MDL-WIS-PA-000005 REV 00 AD 01

Total System Performance Assessment Model/Analysis for the License Application Addendum 01

Addendum Cover Page

Figure 3-2[a]. TSPA-LA Software Architecture

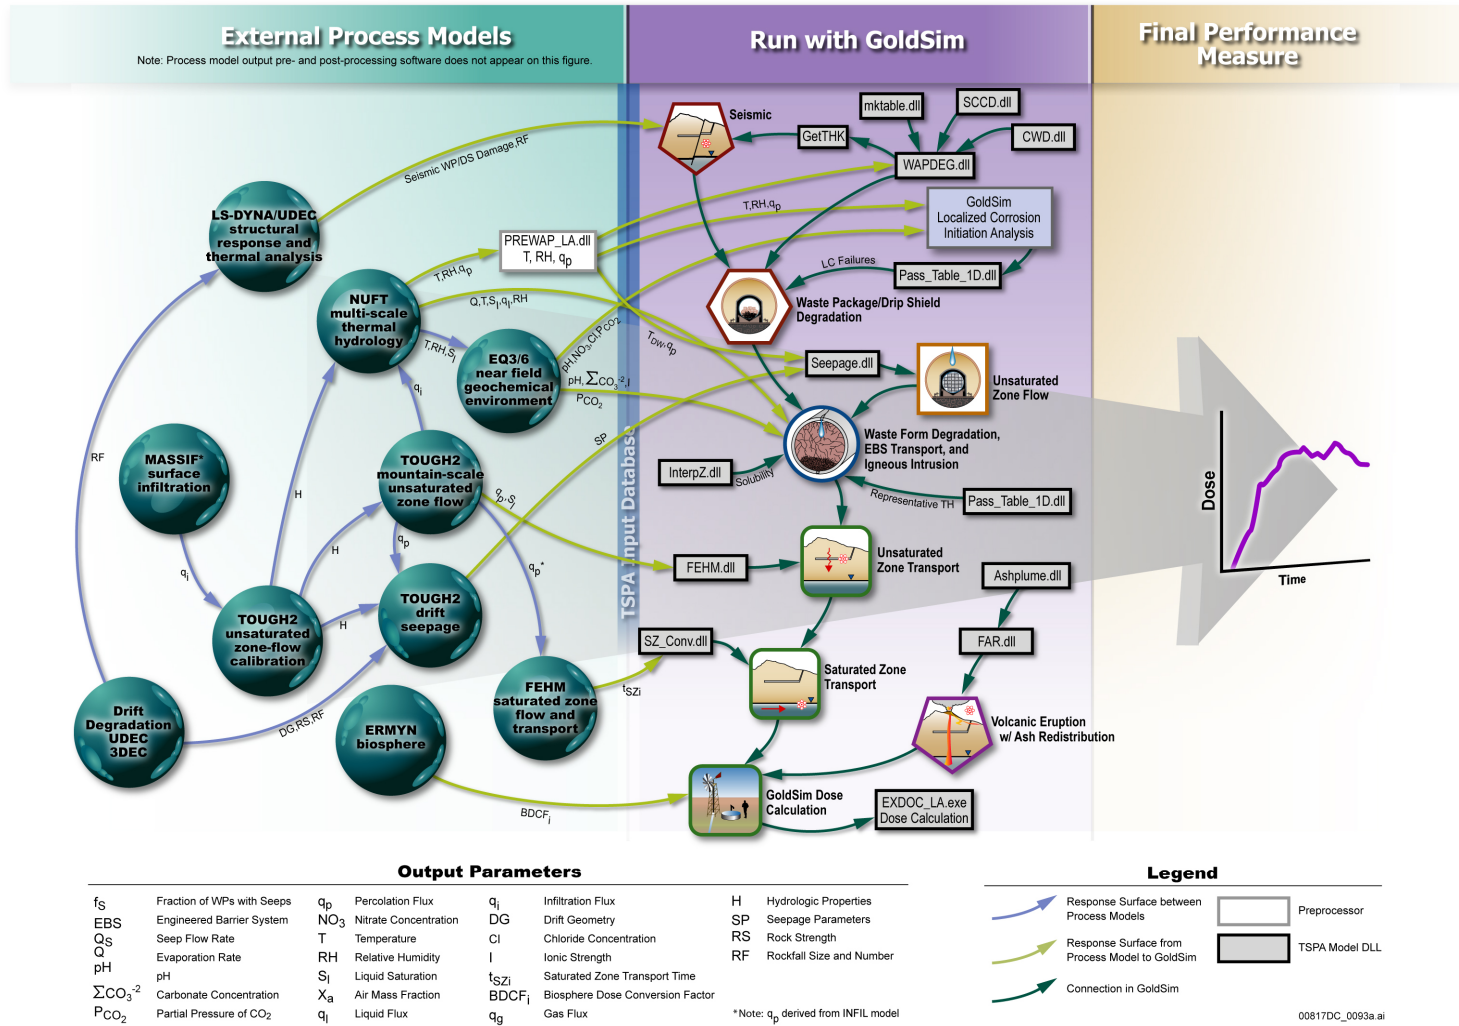
Section 3 of the parent document describes the software used in the development of the TSPA-LA Model. For the analyses presented in this addendum, only additional software or changes in the software used for the model results presented in the parent document are listed in Section 3[a]. In addition, Table 3-1 has been revised with the additional software and is included as Table 3-1[a] of this addendum. In addition, Figure 3-2 of the parent document incorrectly identified the surface infiltration external process model. Therefore, the figure has been updated and is included as Figure 3-2[a] of this addendum.

Figure 6.1.4-5[a]. Information Transfer between the Submodels of the TSPA-LA Volcanic Eruption Modeling Case

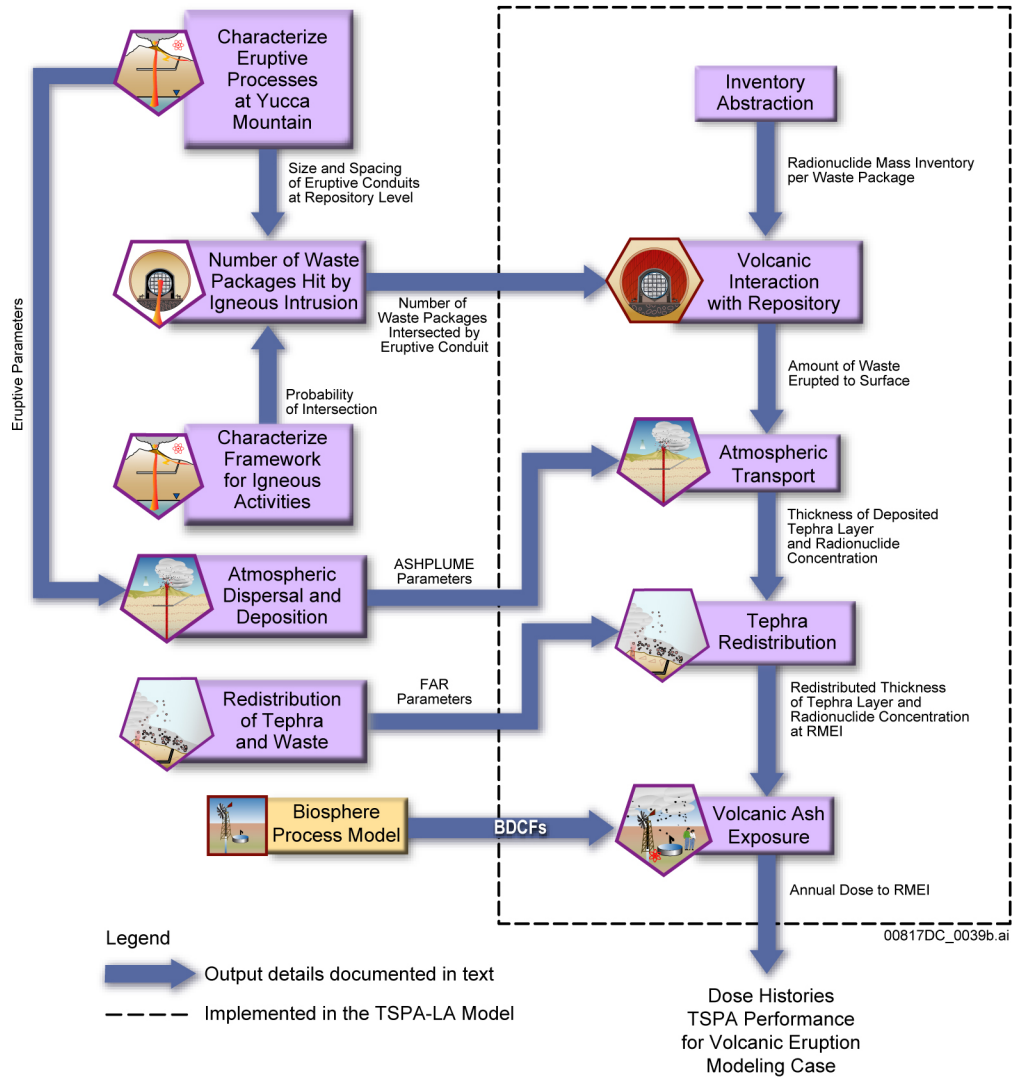
This section in the parent document provides an overview of how model components and submodels are connected within the TSPA-LA Model and how information flows between them. The primary focus of this section is on the description of the TSPA-LA Model for the Nominal Scenario Class. This addendum contains an update that incorporates additional information about the TSPA-LA Model structure and information flow documented in Section 6.1.4.2 of the parent document. In addition, Figure 6.1.4-5 from the parent document has been revised to correct an error in the original figure and is included as Figure 6.1.4-5[a].

Figure 6.3.2-7[a]. Repository Percolation Subregions Used in the TSPA-LA Model (based upon the 10th percentile infiltration scenario, glacial-transition period)

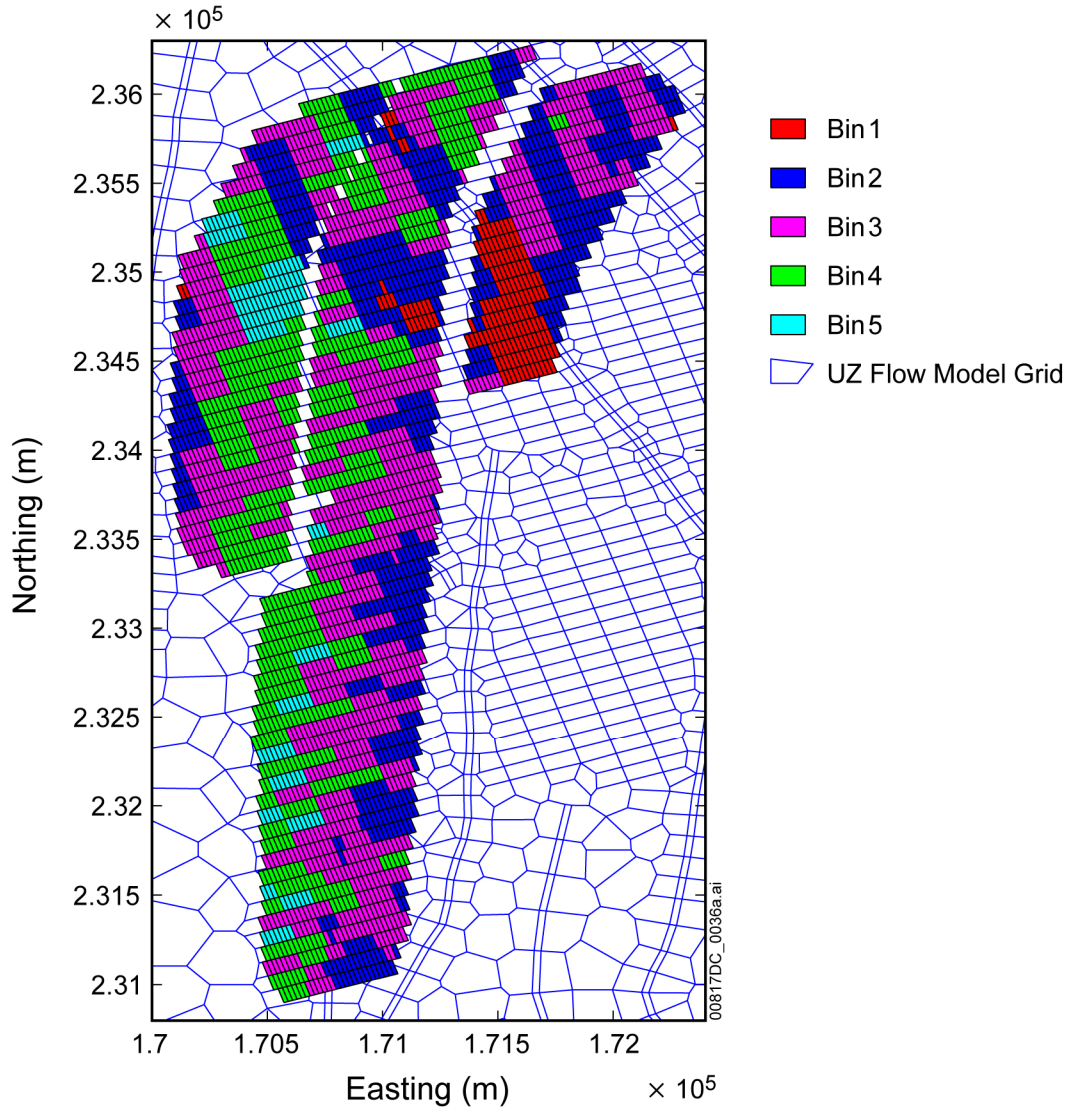
Section 6.3.2.3[a] includes supplemental material to be used in conjunction with the discussion documented in Section 6.3.2.3 of the parent document. The material was inadvertently omitted from Section 6.3.2.3 of the parent document and does not reflect a change in the EBS Thermal-Hydrologic (TH) Environment conceptual model, abstraction, or implementation in the TSPA-LA Model. In addition, the caption for Figure 6.3.2-7 in the parent document has been corrected and is included as Figure 6.3.2-7[a] of this addendum.

Figure 6.3.6-3[a]. Illustrative Cross Section of a Typical Emplacement Drift

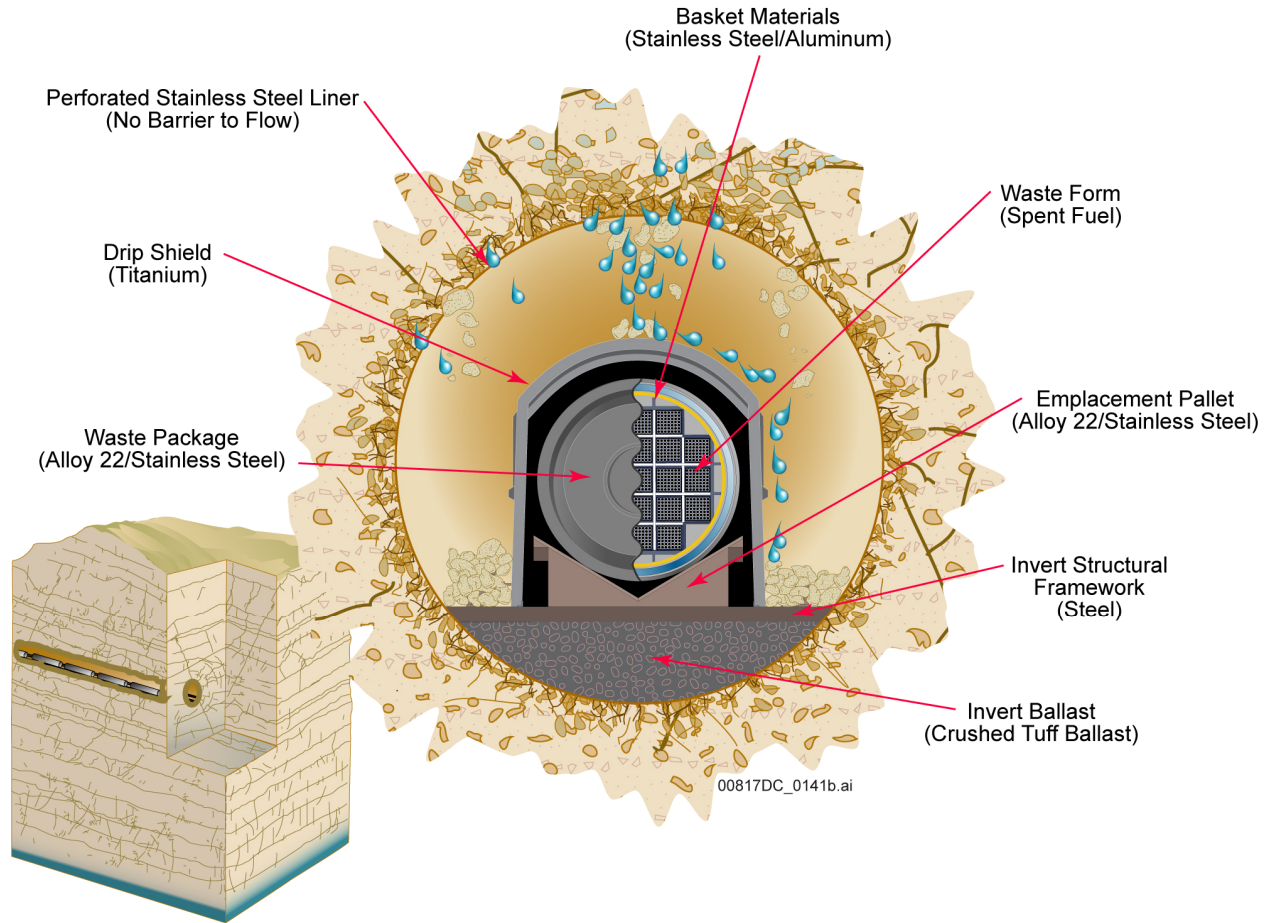
Figure 6.3.6-3[a] has been revised from the parent document to illustrate a representation of a typical emplacement drift according to the current design.
